Subject: Plate Clamp

DESIGN REVIEW REPORT

PLATE CLAMP

Report No.	TUVR-24093-262008631-DRR-01	Revision	0
Place of Issue	Doha, Qatar	Date of Issue	October 21, 2024
Client	Dutest Qatar

Figure 4.1: Details of Plate Clamp

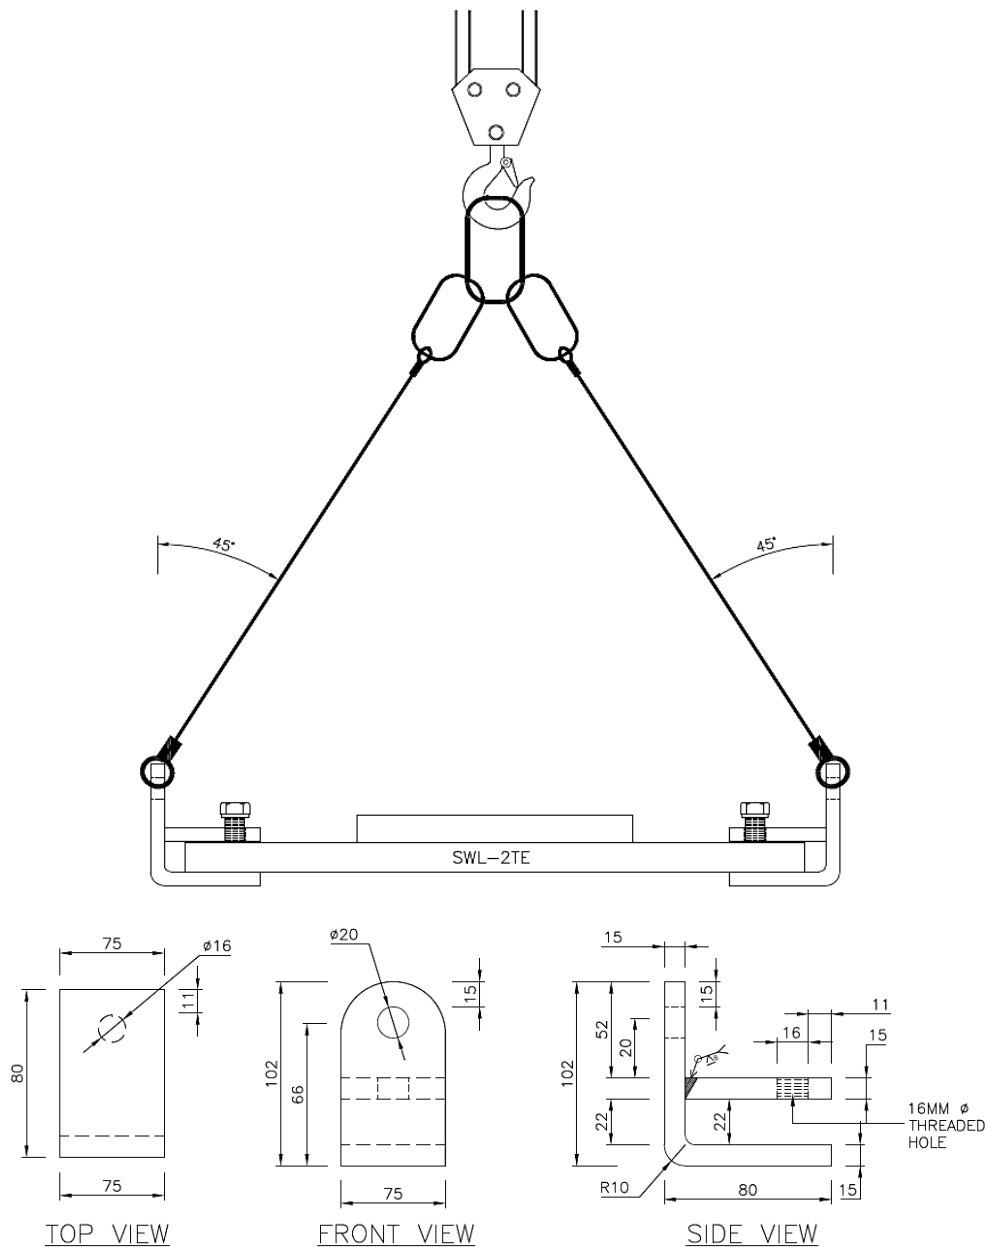
- (2) As shown in Figure 4.1 above, the vertical load of 2 tonnes will be lifted using two plate clamps with sling angle from vertical of 45° (maximum). This is considered as the final and maximum loading condition. It is the responsibility of the client to ensure that

the actual lifting operation will not involve loads that could potentially results to stress greater than the design loading condition as permitted in BS EN 13155:2020. Such condition deemed beyond the scope of this design review.

Figure 4.2: Von Misses stresses in Plate Clamp at Elastic and Yielded Condition per BS EN 13155:2020

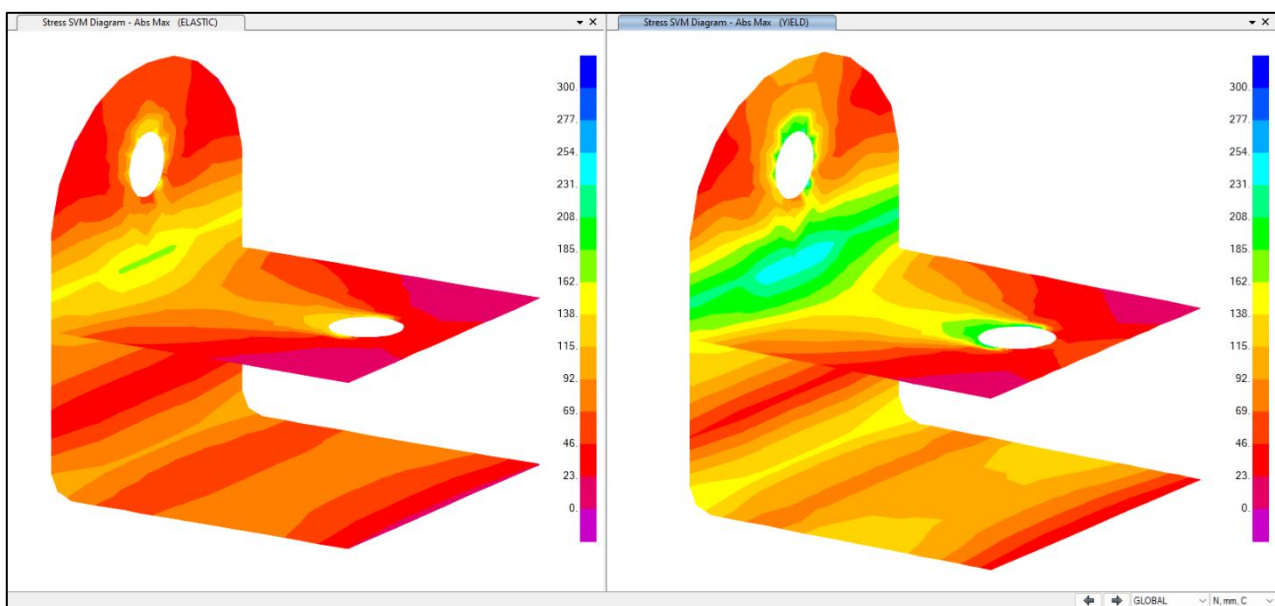
- (3) The Plate Clamp shall be limited for use up to 16,000 load cycles only.
- (4) The design assumptions, boundary conditions and acceptance criteria were reviewed and found acceptable.
- (5) The Client is to ensure that the securing bolts are tight enough to secure the load during lifting.
- (6) TUVR has performed an independent analysis and design verification of the Plate Clamp following the design requirements of BS EN 13155:2020 and other relevant design standards (see list in Part 3.2). Based on the results of the analysis and design verification, it was found that the Plate Clamp sufficient mechanical strength to carry the load of 2 tonnes.
